CHANGE REQUEST

✂ 25.926 CR 015 ✂ rev 2 ✂ Current version: 3.2.0 ✂

Title:	✂ Correction on parameter "Maximum total number of transport blocks..."		
Source:	✂ Mitsubishi Electric (Trium-RD)		
Work item code:	✂ Release 99 issues	Date:	✂ 23 rd November 2000
Category:	✂ F	Release:	✂ R99
	Use <u>one</u> of the following categories: F (essential correction) A (corresponds to a correction in an earlier release) B (Addition of feature), C (Functional modification of feature) D (Editorial modification)		Use <u>one</u> of the following releases: 2 (GSM Phase 2) R96 (Release 1996) R97 (Release 1997) R98 (Release 1998) R99 (Release 1999) REL-4 (Release 4) REL-5 (Release 5)
	Detailed explanations of the above categories can be found in 3GPP TR 21.900.

Figure 4.1: UE transport channel processing limitations in uplink

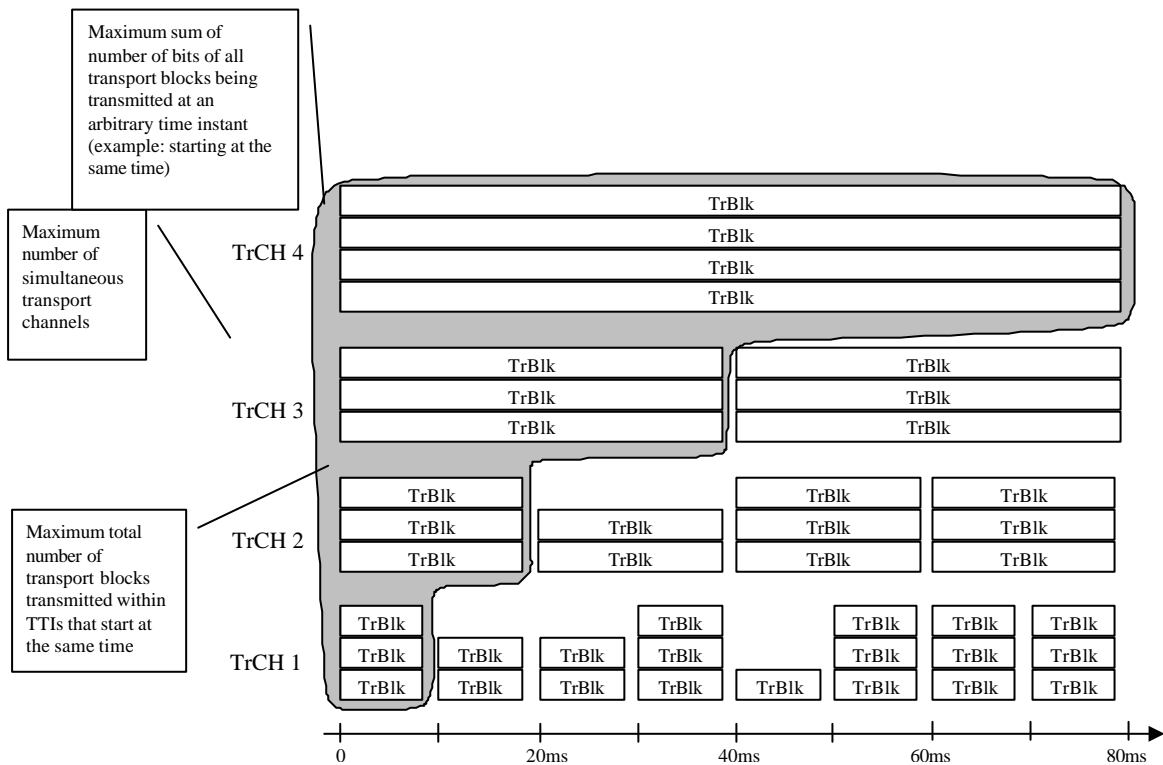
Clauses affected:	✂ 4.5.1, 4.5.2.		
Other specs affected:	<input type="checkbox"/> Other core specifications <input type="checkbox"/> Test specifications <input type="checkbox"/> O&M Specifications	✂	
Other comments:	✂ There were revision marks in figure 4.1. in the original document. These revision marks were forgotten to be accepted. We have accepted them when editing the CR to avoid confusion.
